TECHNICAL SERVICE BULLETIN

Underbody Shield Rattle Or Flutter Noise While Moving - Built On Or Before 05-Jun-2019

21-2322
23 September
2021

Ford 2015-2019 Edge
Lincoln 2016-2018 MKX
2019 Nautilus

Figure 1

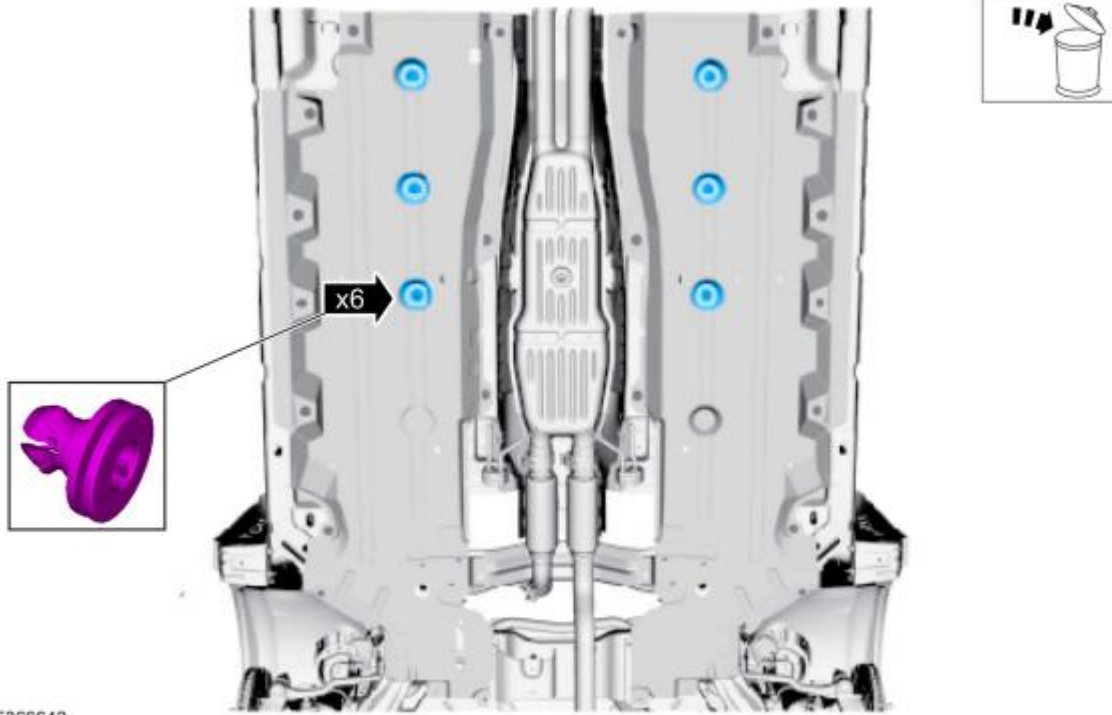
Issue: Some 2015-2019 Edge, 2016-2018 MKX, and 2019 Nautilus vehicles built on or before 05-Jun-2019 may exhibit a rattle or flutter noise from the underbody of the vehicle while moving. This may be due to the movement of loose underbody shield fasteners which are attached to the underbody shields. To correct the condition, follow the Service Procedure to remove the assembly aid fasteners.

1. Raise the vehicle on a hoist. Refer to Workshop Manual (WSM), Section 100-02.
2. Remove and discard the assembly aid fasteners. (Figure 1)
